December 9<sup>th</sup>, 2016

**Re: NIRB File 03MN107 – Agnico Eagle’s response to Nunavut Impact Review Board’s 2015-2016 Annual Monitoring Report for the Meadowbank Gold Project and Board’s Recommendations**

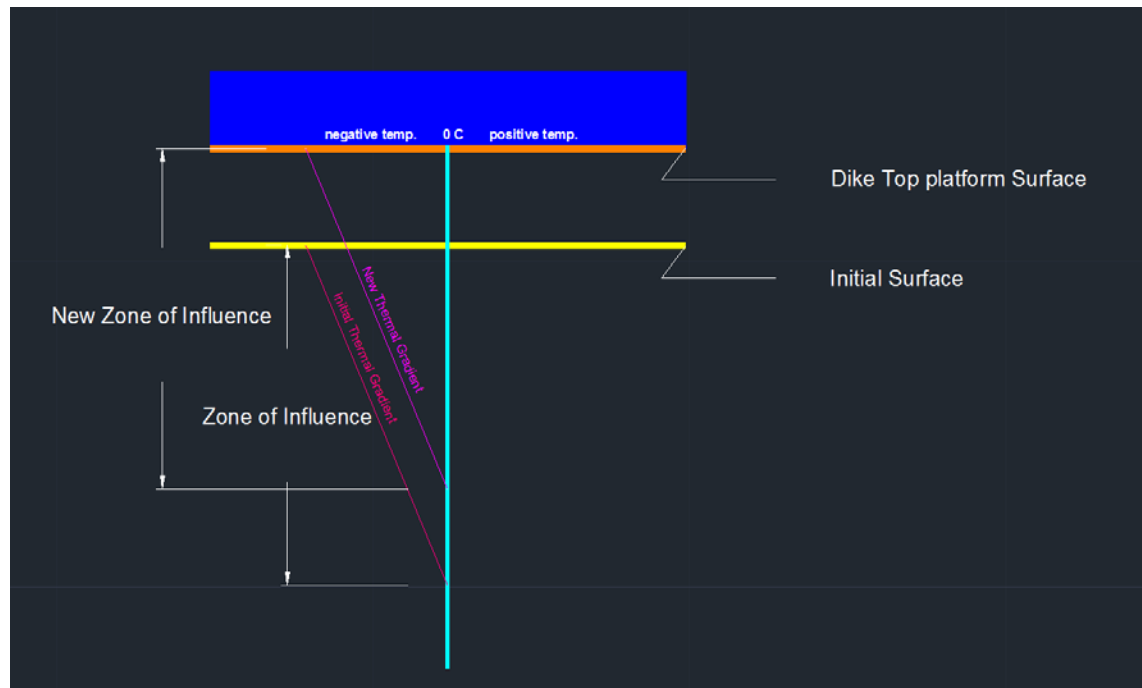
**Concern:** AEM reports that the dike foundation of Saddle Dam 1 remains frozen year-round, but that the temperature of the foundation material (soil and bedrock) has increased by an average of 4-5°C since 2010, depending on location within the dike. No subsequent discussion or interpretation of this temperature increase is presented.

**Recommendation 23:** AEM should place the reported Saddle Dam 1 temperature increases into context. For example, is the 4-5°C unusual or unexpected? What is the reason for the increasing trend since 2010? What are the implications for the dike’s integrity? What are the predictions for temperature change in the future within this dike, given climate change?

*To understand and predict how a permafrost foundation will behave overtime, it is important to first understand the permafrost creation mechanism on land. The permafrost condition is created from one specific frontier condition. This frontier is the cold atmosphere. From the laws of thermodynamics, conservation of energy and equilibrium, the permafrost regime operates on a full year basis cycle. When an infrastructure is put in place, the frontier is moved upward. This means that the depth of influence is also move upwards. Concretely, for the saddle dam 1, it is normal and expected to observe an increase in the temperature in parts of the permafrost foundation since its construction. The dike itself moves the cold atmosphere frontier condition upward and then forces a rearrangement of the permafrost equilibrium at this specific emplacement. For more clarity, please refer to the figure presented below. Since the completion of the construction, the system is progressing to reach a new equilibrium. Please refer to the graph provided below of the thermistor SD1-T3 for visual*

### **Vault Area Sampling Location**

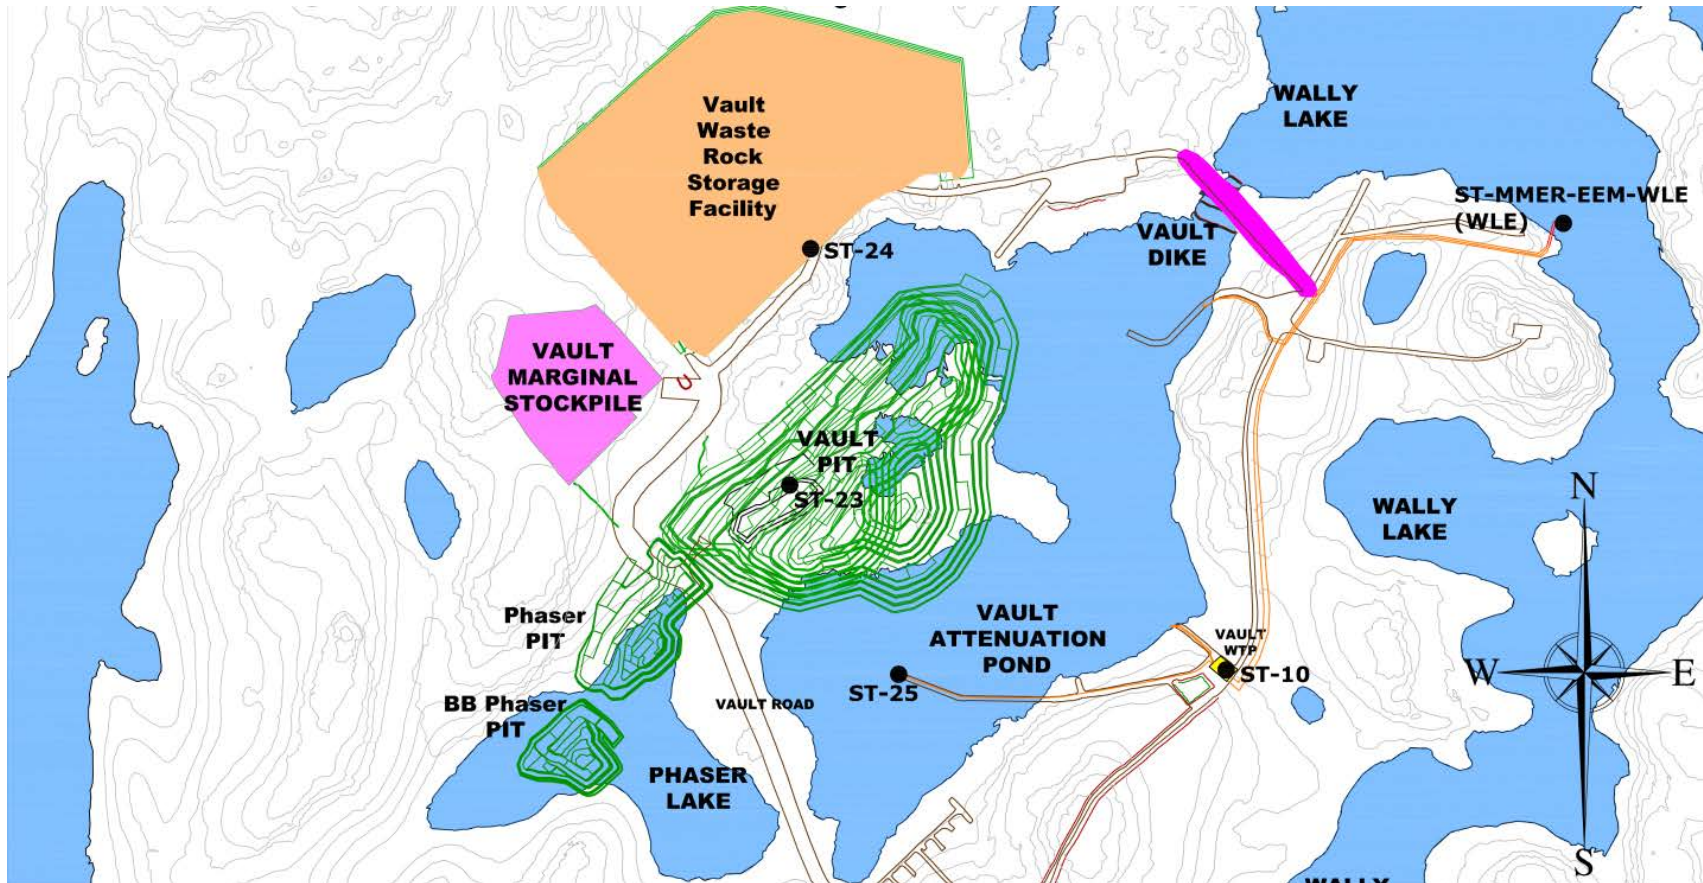
- Is ST-MMER-2 the discharge location?
- Is WLE the same as ST-MMER-2-EEM-WLE? Where is WLE on Figure 3?
- Is TPS the same site as ST-MMER-1-EEM-TPS?

*Agnico Eagle omitted to put WLE on Figure 3 of the 2015 Annual Report, so please refer to figure in Appendix A for the exact sampling location. Agnico Eagle will make sure to illustrate all sampling locations in the 2016 Annual Report.*
